City of Phoenix
 PLANNING AND DEVELOPMENT DEPARTMENT

Staff Report Z-84-16-4
 December 8, 2016

Alhambra Village Planning Committee Meeting Date: December 20, 2016
Planning Commission Hearing Date: January 5, 2017
Request From: C-2 TOD-1 (0.93 acres), P-1 TOD-1 (0.99 acres)
Request To: WU (Walkable Urban Code) T5:5 SL (1.92 acres)
Proposed Use: Multifamily residential (senior housing)
Location: Northwest corner of 16th Avenue and Camelback Road
Owner: Saia Family Limited Partnership
Applicant/Representative: Benjamin Graff, Withey Morris, PLC
Staff Recommendation: Approval, subject to stipulations

Site Plan date stamped November 10, 2016 (1 page)

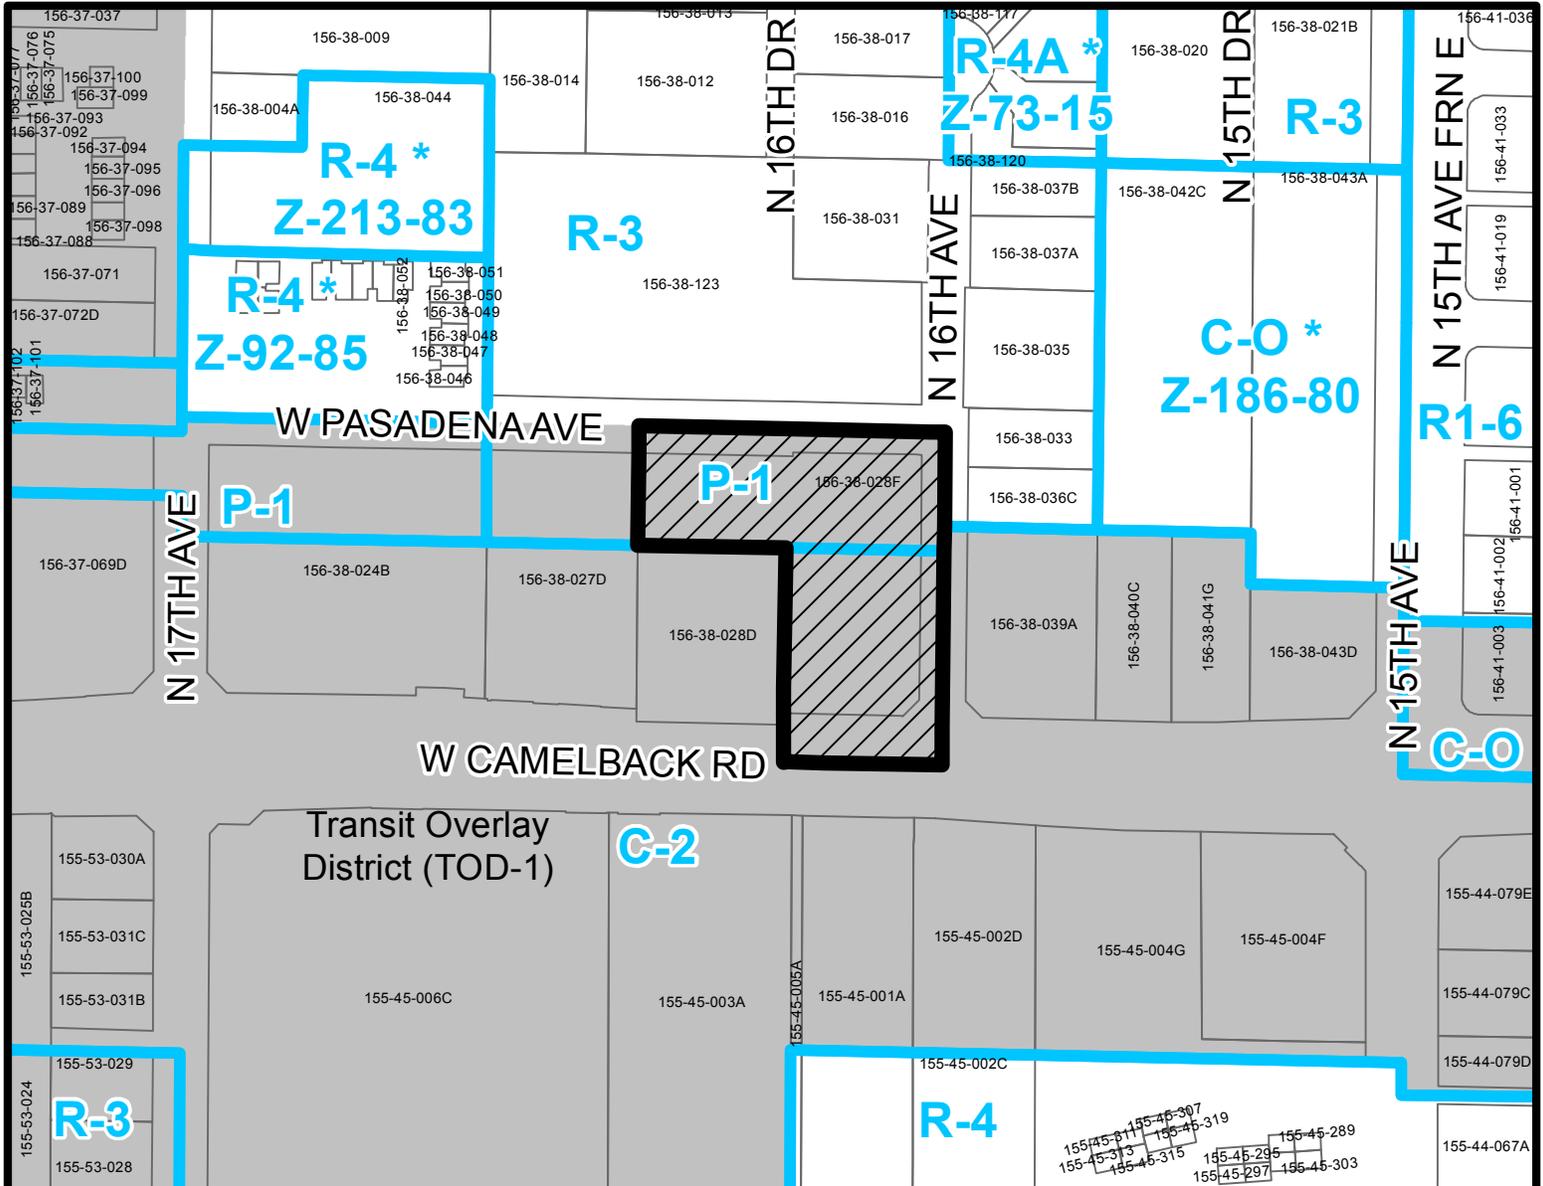
8. The conceptual site plan proposal shows a common entry located at the ground floor facing Camelback Road. A vehicular entrance is shown off 16th Avenue and another off Pasadena Avenue. Sidewalks are shown to be detached from the curb, allowing trees to be planted between the curb and the sidewalk and providing a more comfortable environment for pedestrians. This design is consistent with the City Council adopted Guiding Principles for Complete Streets, one tenet of which is to make Phoenix more walkable.

9. The conceptual site plan shows one common entry located along Camelback Roads (primary) frontage and no frontage types specified along the 16th avenue and Pasadena Avenue (secondary) frontages. The Walkable Urban (WU) Code Section 1303 Transect lot standards require that when a common entry frontage type is utilized under the T5 transect that a minimum one entry per 50 feet of primary frontage and one entry per 80 feet of secondary frontage be required. Additional Frontage Standards can be found in the WU Code Section 1305. Given the site plans inconsistency with these standards of the WU Code, staff is not recommending a stipulation of general conformance. The applicant is encouraged to continue working with staff to update their proposal as it proceeds through the site development review process. The proposal will need to be updated to meet the provisions of the Walkable Urban Code prior to site plan approval.

11. The Comprehensive Bicycle Master Plan supports options for both short- and long-term bicycle parking as a means of promoting bicyclist traffic to a variety of destinations. The conceptual site plan proposes 22 bicycle parking to meet the provisions of the Walkable Urban Code. It is recommended that two types of parking be provided on the property: secured parking for employees, and short-term rack parking for guests located near entrances to the property. The property is near a light rail transit station and several major bus routes. Providing secure bicycle parking for residents and parking for guests of the development is supportive of multimodal travel options. Secured bicycle parking can be provided in bicycle lockers or in locked bicycle rooms. The applicant will work with Planning and Development staff through the site review process to determine locations for both types of bicycle parking as well as for the manner in which the secured parking will be provided. The short-term bicycle racks should be an inverted-u design where both ends of the "U" are affixed to the ground and installed per the requirements of Walkable Urban Code. These provisions are addressed in Stipulations #3 and #4.

2. The developer shall (re)construct sidewalk and landscape improvements to comply with Section 1312.E. of the Zoning Ordinance, as approved by the Planning and Development Department.

3. A minimum of 6 inverted-U bicycle racks for guests shall be provided on site, located near an entrance to the business, and installed per the requirements of Section 1307.H.4. of the Zoning Ordinance, as approved by the Planning and Development Department.

4. A minimum of 16 secured bicycle parking spaces shall be provided on site, as approved by the Planning and Development Department.
5. The developer shall update all existing off-site street improvements (sidewalk, curb ramps, and driveways) to current ADA guidelines, as approved by Planning and Development Department.

PRELIMINARY LANDSCAPE PLAN

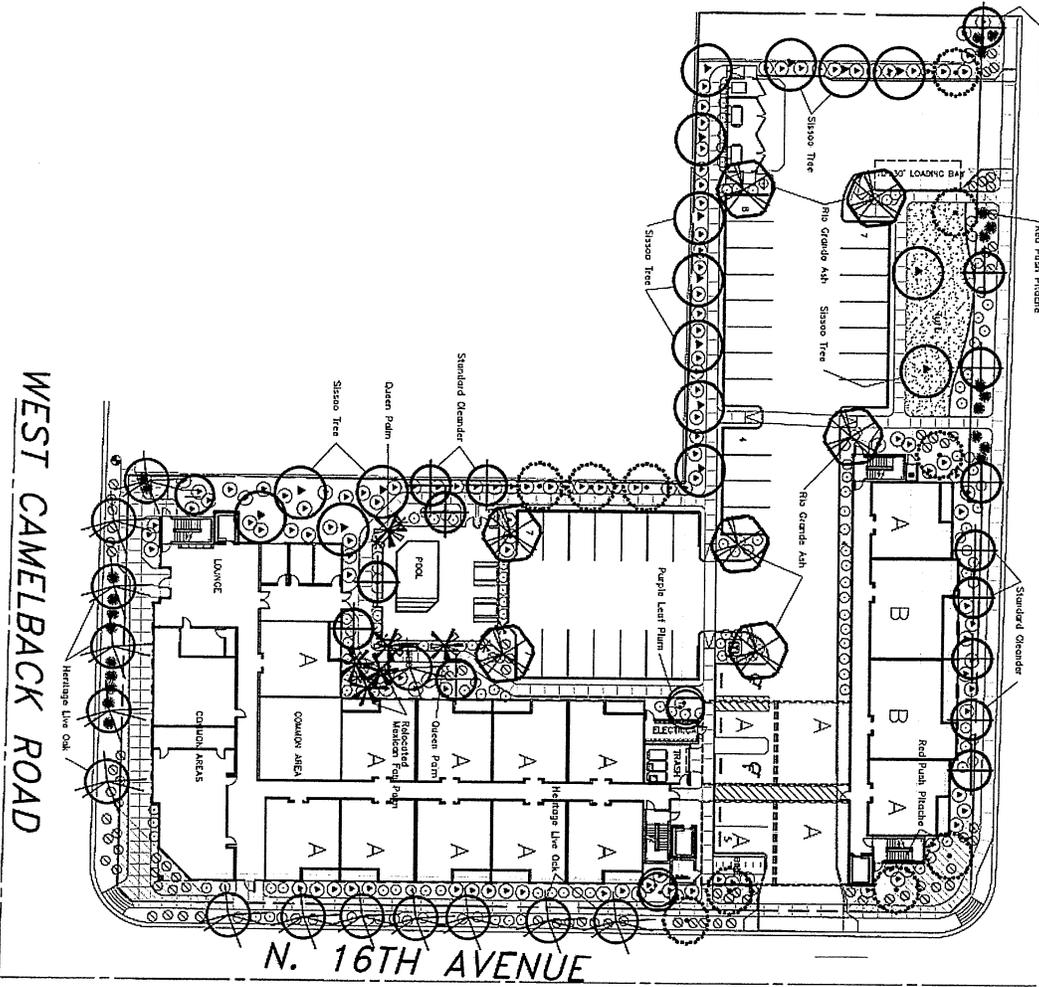
10. The Tree and Shade Master Plan has a goal of treating the urban forest as infrastructure to ensure that trees are an integral part of the city's planning and development process. Toward that end, development of this site will contribute to the urban forest infrastructure through the provision of trees along the right-of-way. Further, the sidewalks will be detached from the curbs, allowing trees to be planted to shade and separate pedestrians from vehicles on the street. These provisions are addressed in Stipulation #1.

1. The developer shall work with Planning and Development Department to determine a type of tree appropriate for the Camelback Road street frontage which will also provide the shade required by the Walkable Urban Code.
